**PLANNING COMMISSION MEETING**  
**LOCATION: TOWNSHIP ANNEX, 7527 HIGHLAND, WHITE LAKE, MICHIGAN 48383**  
**(FORMER WHITE LAKE LIBRARY)**  
**THURSDAY, OCTOBER 21, 2021 – 7:00 PM**

**RE: Pontiac Lake Overlook (FKA Pontiac Lakeview Apartments)- Final Site Plan/Final Engineering Plan-2<sup>nd</sup> Review**

**Subject:** 8565 Pontiac Lake Road  
Pontiac Lake Overlook Apartments Final Site Plan Review #2  
Tax Parcel No. 12-13-328-003

**RE: 8565 Pontiac Lake Road  
Pontiac Lake Overlook Apartments Final Site Plan Review – 2<sup>nd</sup> Review  
Parcel Number 12-13-328-003**

SCALE 1" = 30'
SHEET 2 OF 9
KE 2019.071

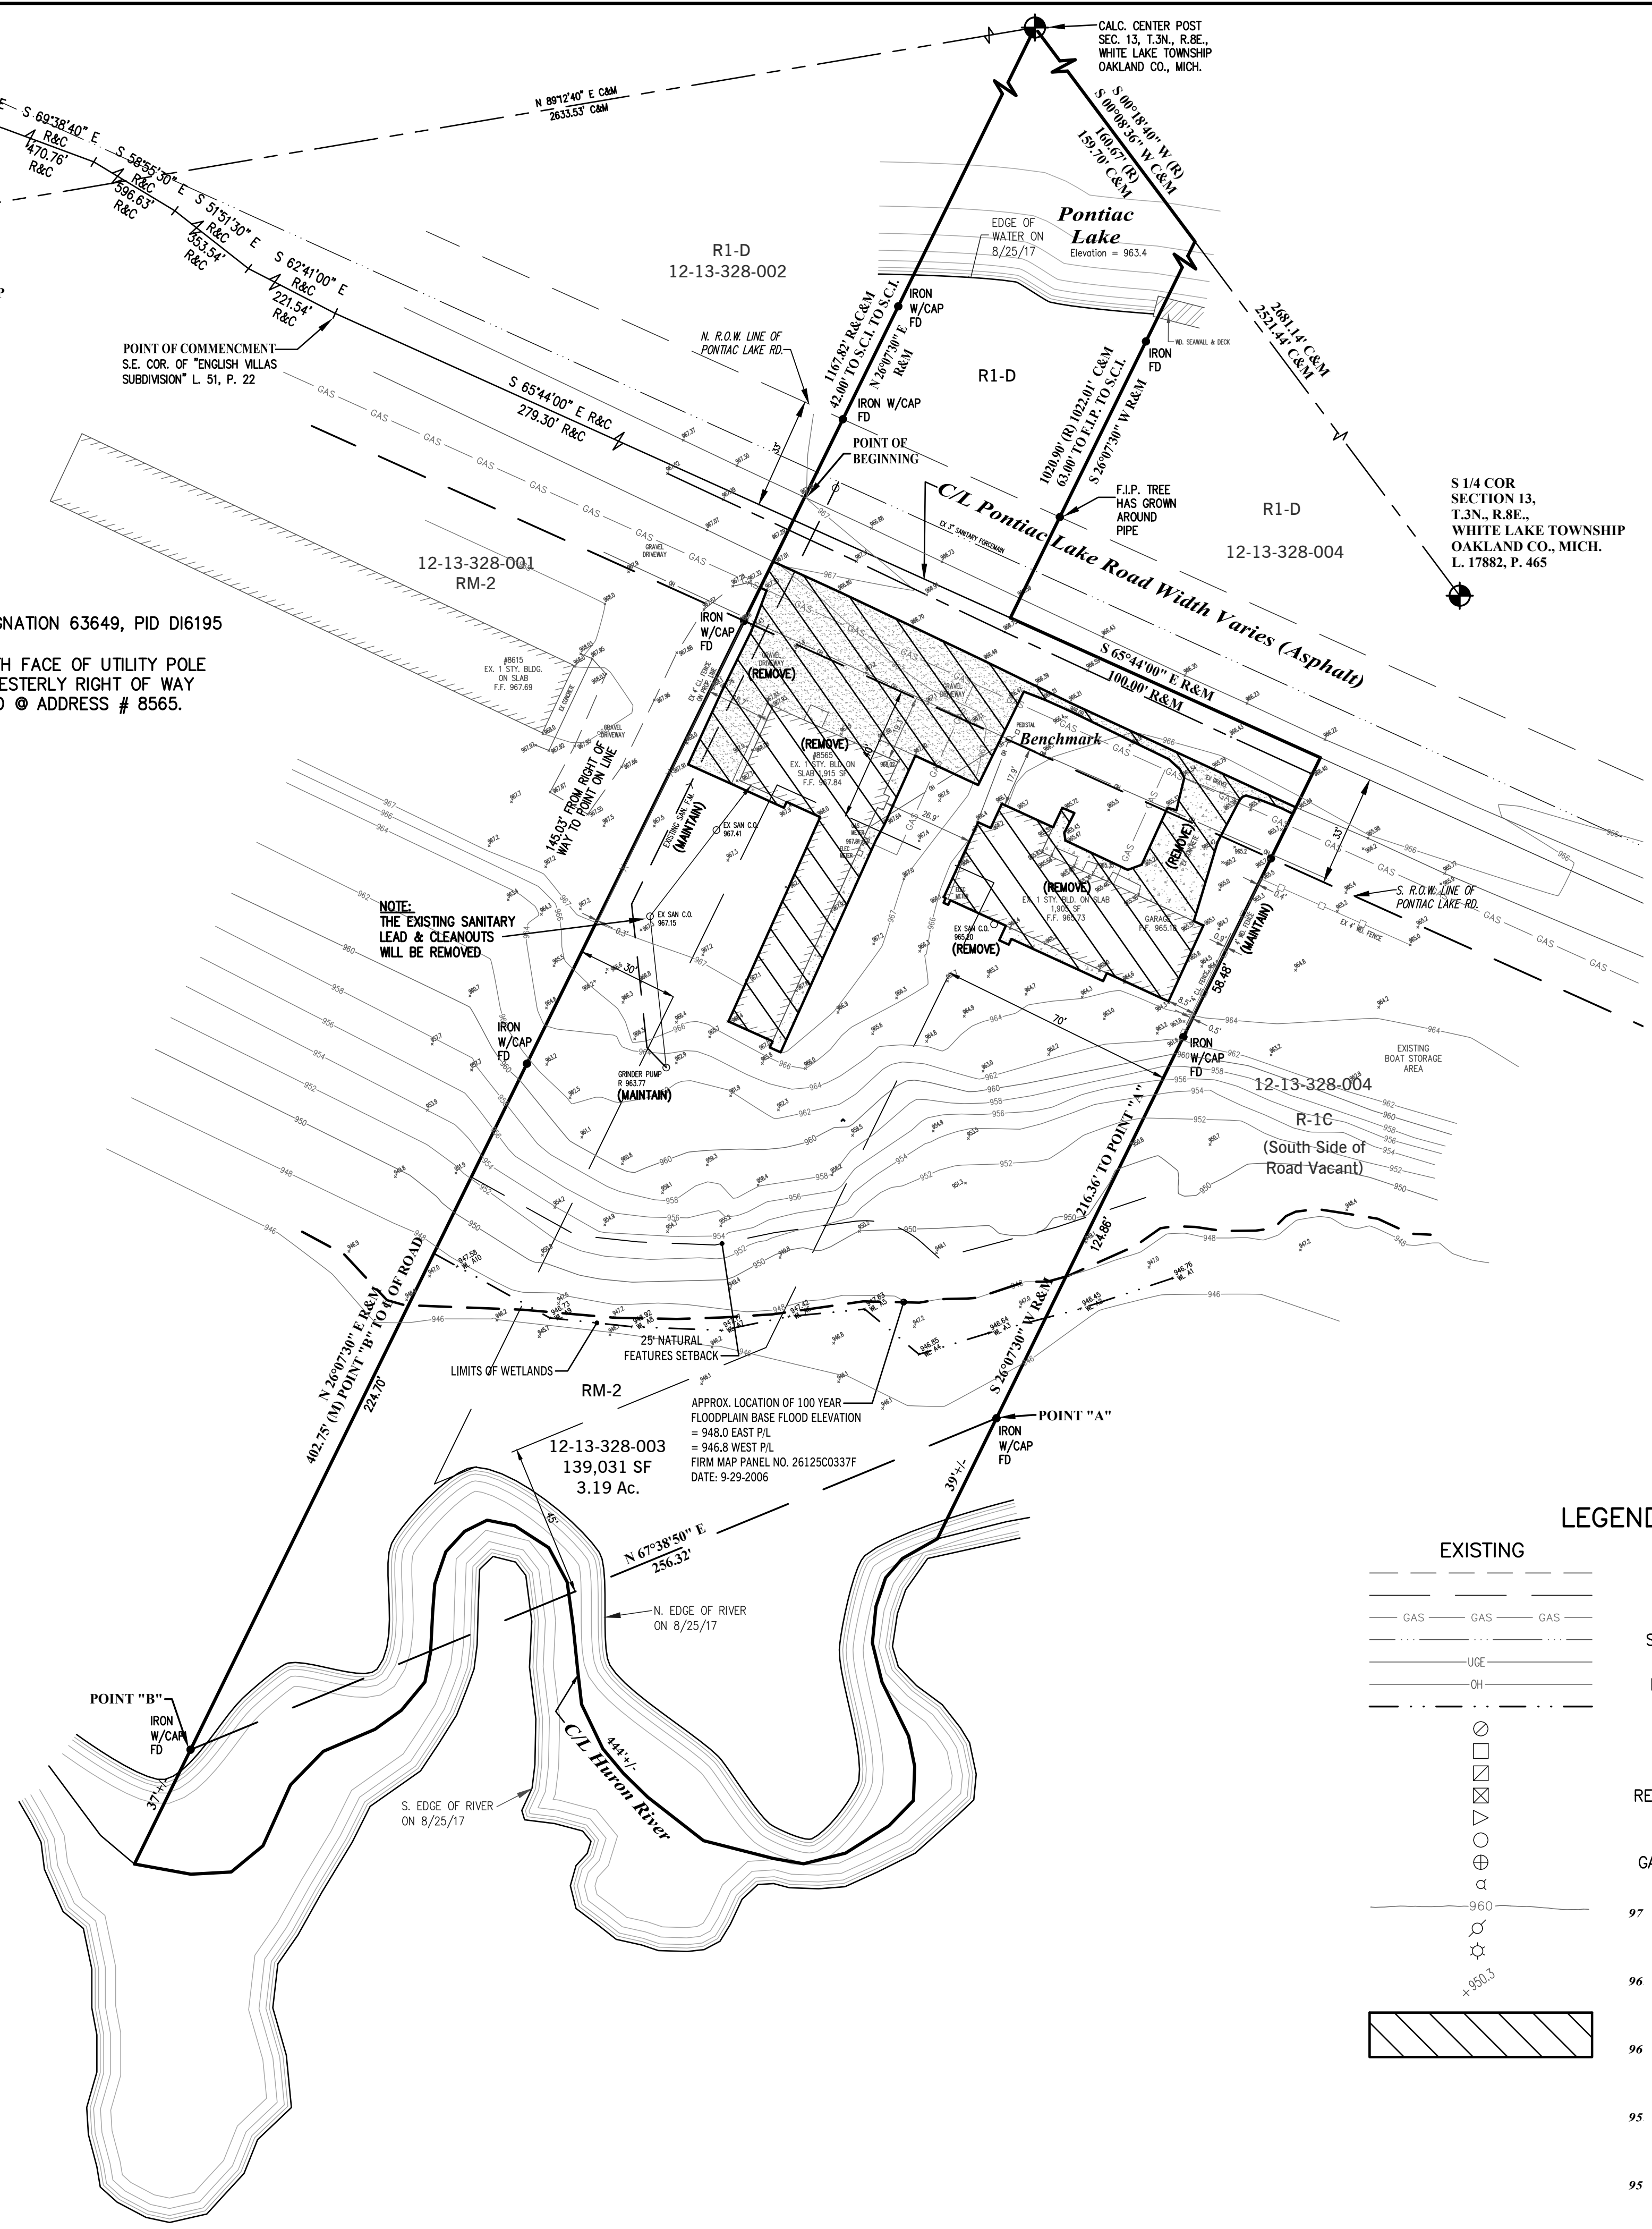
1. *Indicate whether existing fence along the eastern property line is to remain.* **Comment addressed. A note has been added to Sheet 2 indicating that the existing fence shall be maintained.**

**Underground Detention Basin**

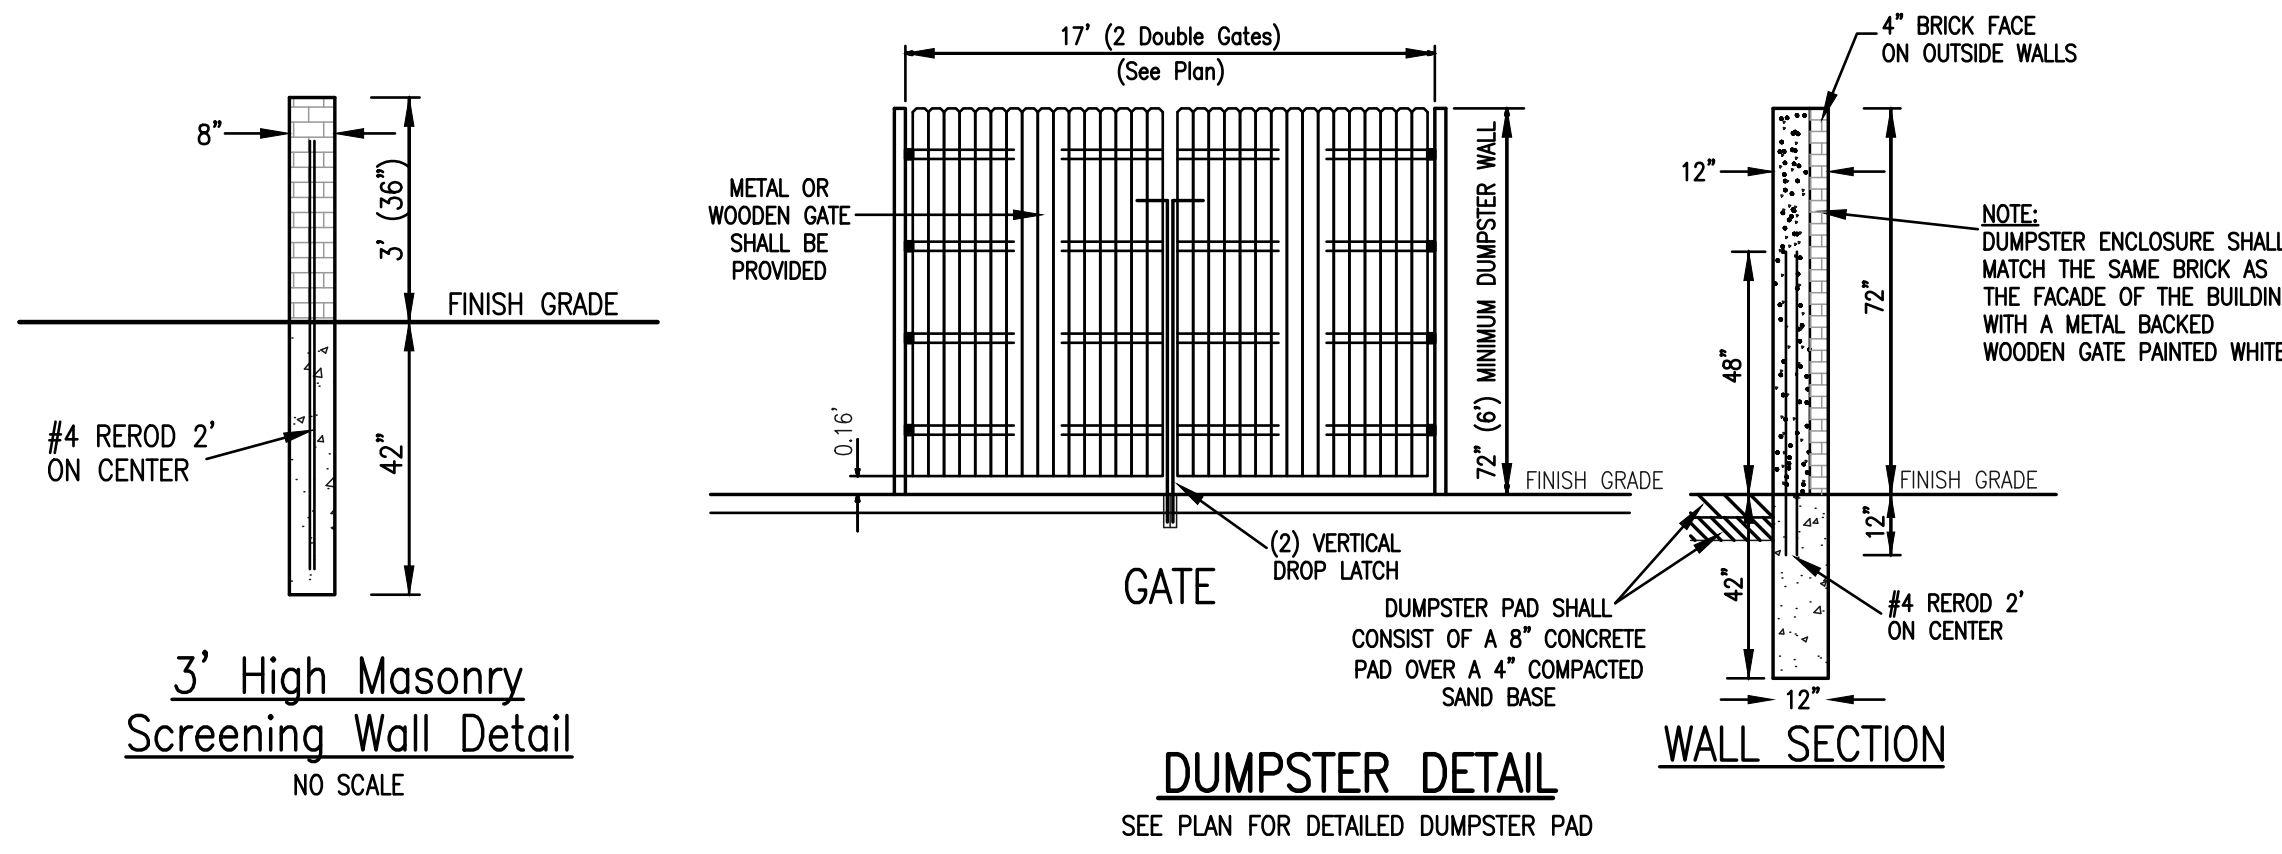
2. *Provide 3" restrictor location on storm sewer profile on Sheet 4. **Comment addressed.***
3. *Plan sheet 4 indicates "See Contech Plans for Details" of the underground detention system. Please provide the detention system details in the plan set. **Comment outstanding. Design engineer has noted that Contech plans are in process.***

4. *Sheet 4- Clarify pipe footage for the underground detention piping. Plan shows 52' and 40' for 96" piping (0' for 24" piping); profile shows 50' of 96" pipe only; Quantities listing on Sheet 3 shows 130' of 96" piping and 40' of 24" piping. Assure all quantities and sizes match between plan, profile, and Quantities listing. **Comment addressed.***

**5' wd, 4" Thick Concrete Sidewalk**  
NO SCALE

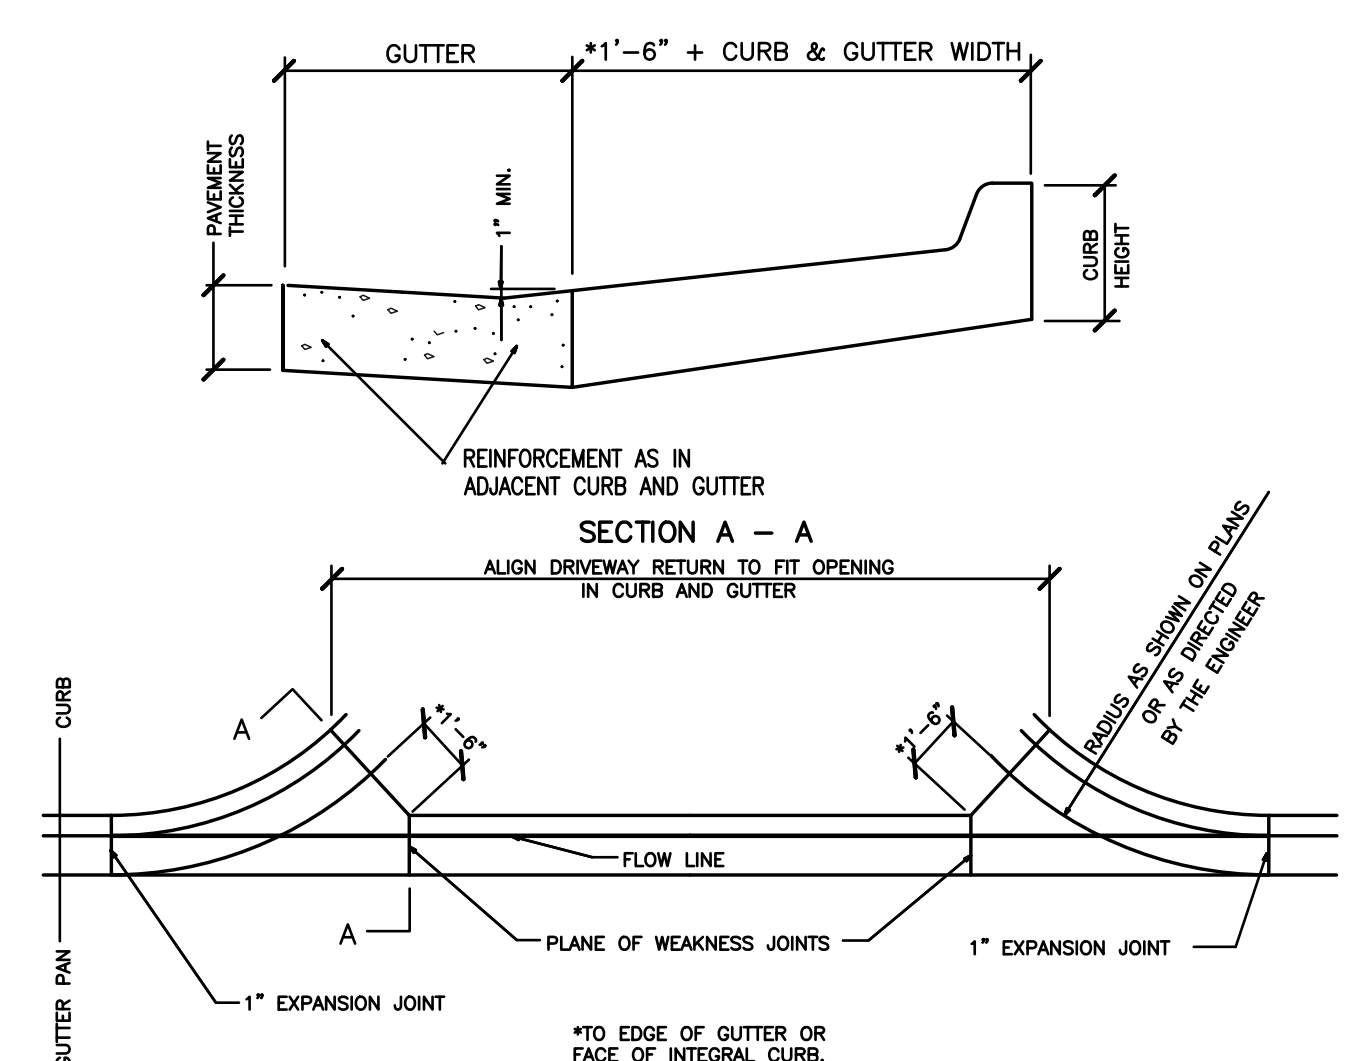
7. *Sidewalk in front of building shall be 7' wide or 5' with bumper blocks at the head of parking spaces. (Ord. 5.11 Q xv.-xviii.). If 7' sidewalk is to be installed, please change detail on Sheet 5 to 7' instead of 5'.* **Comment addressed.**
